FRONT GRADE

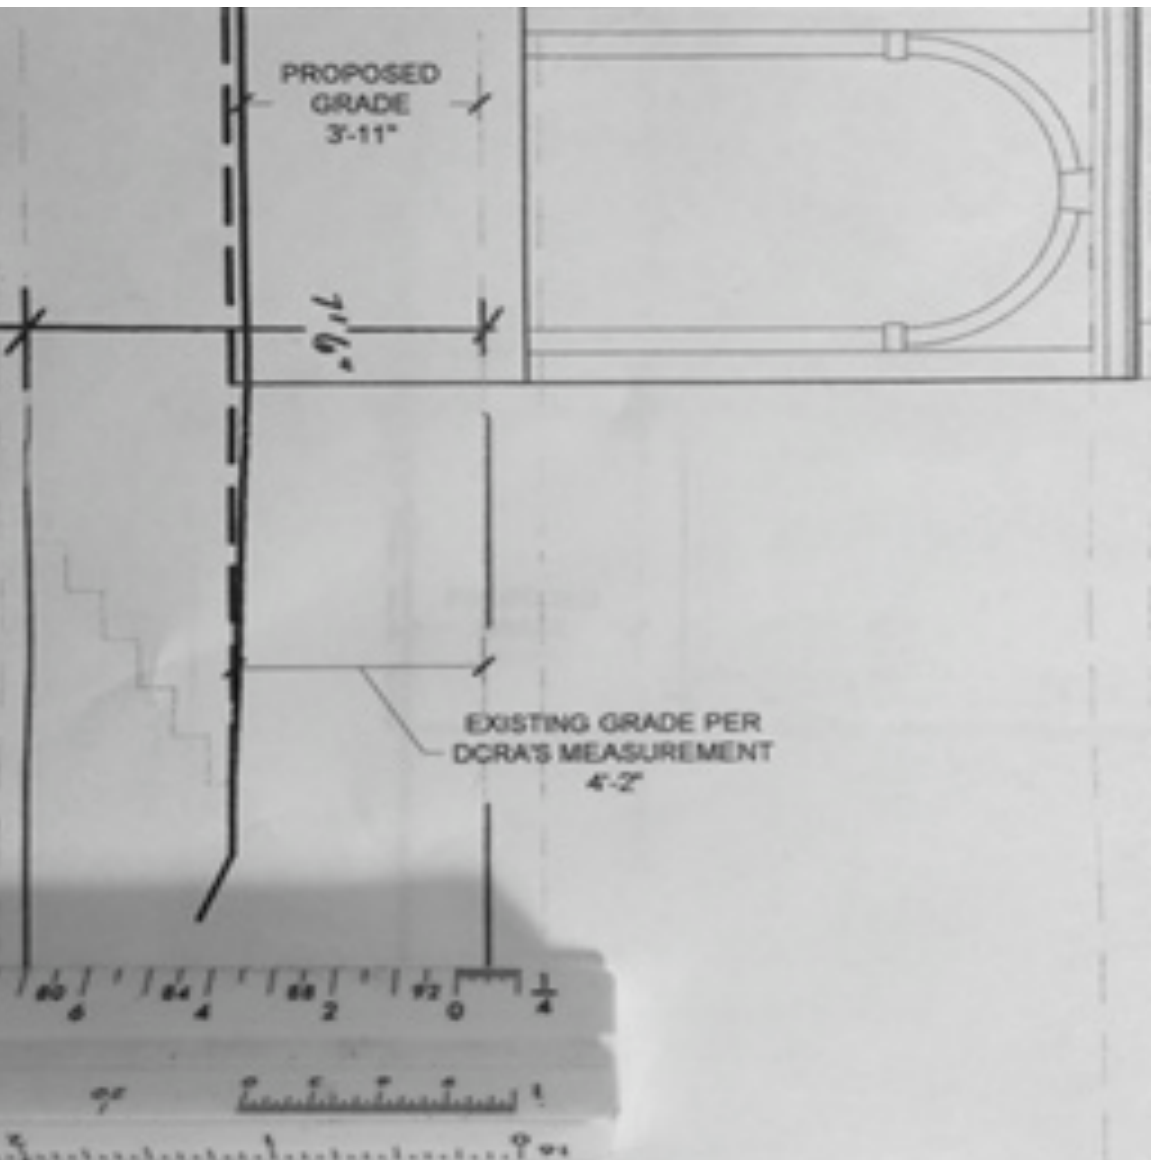
DCRA Notes Existing Grade as 4'2" Establishes
Lower Level Front Grade as Basement. Drawing
Misrepresents Grade as 3'11" A0201 (12/17/14)

FRONT GRADE

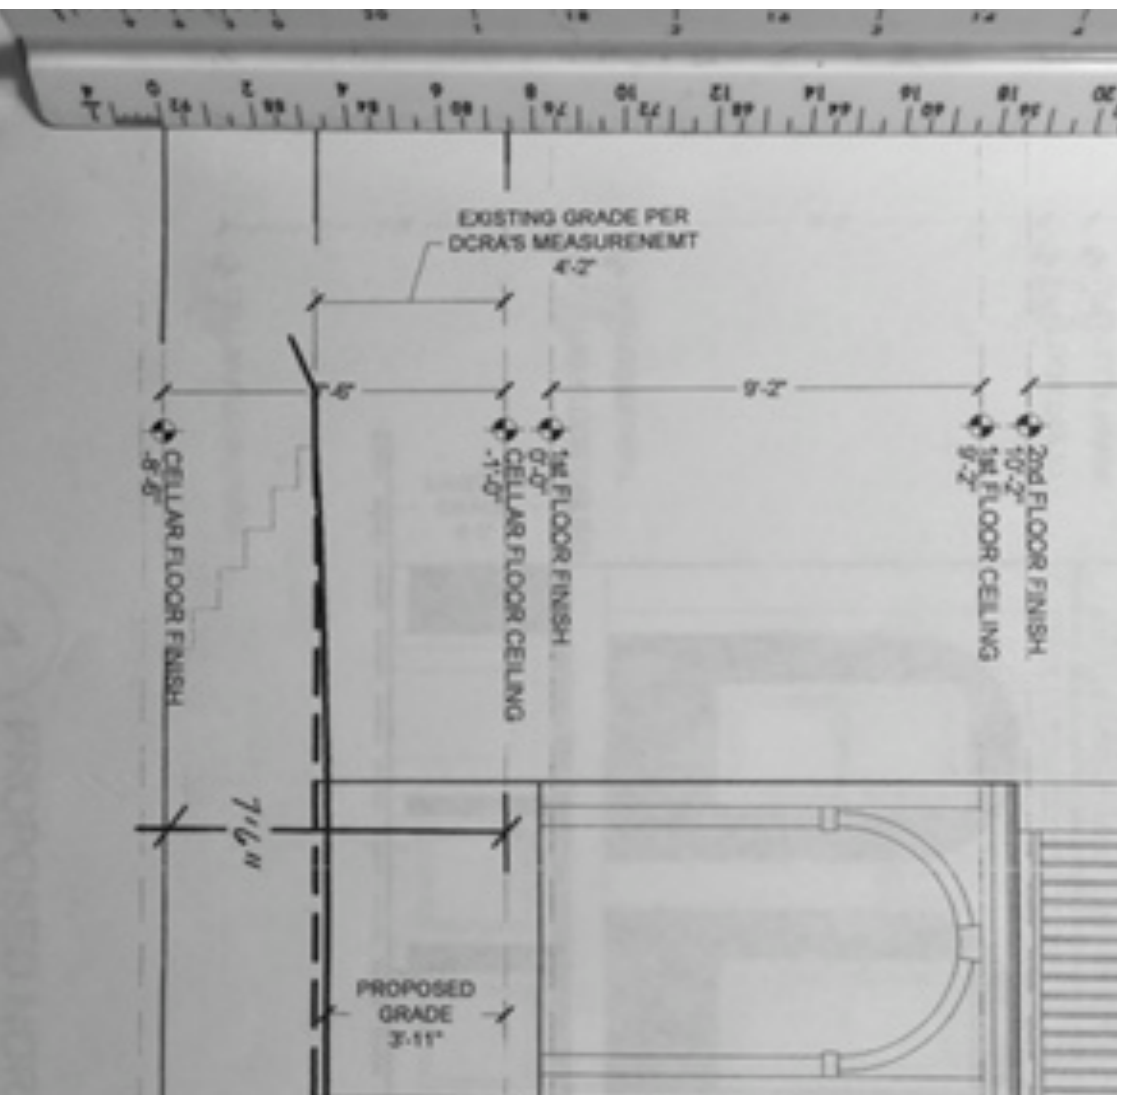
DCRA Notes Existing Grade as 4'2" Establishes Lower Level Front Grade as Basement.

Drawing Misrepresents Grade as 3'11"

REAR GRADE

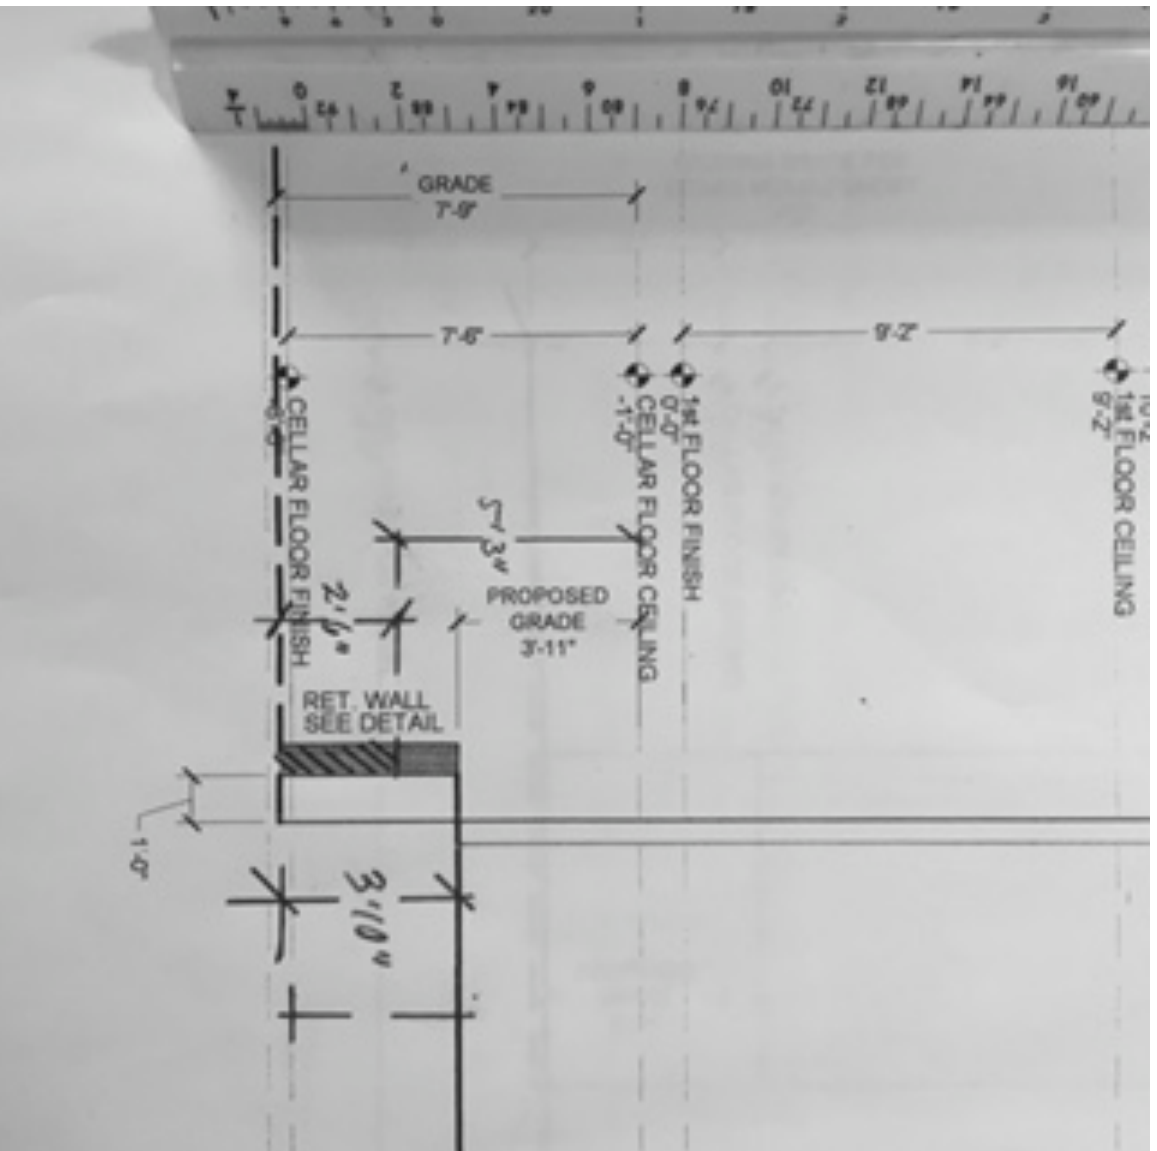
Misrepresents Retaining Wall as 3'10". Grade would be 5'3" if constructed as permitted at 30" height
A0201 (12/17/14)
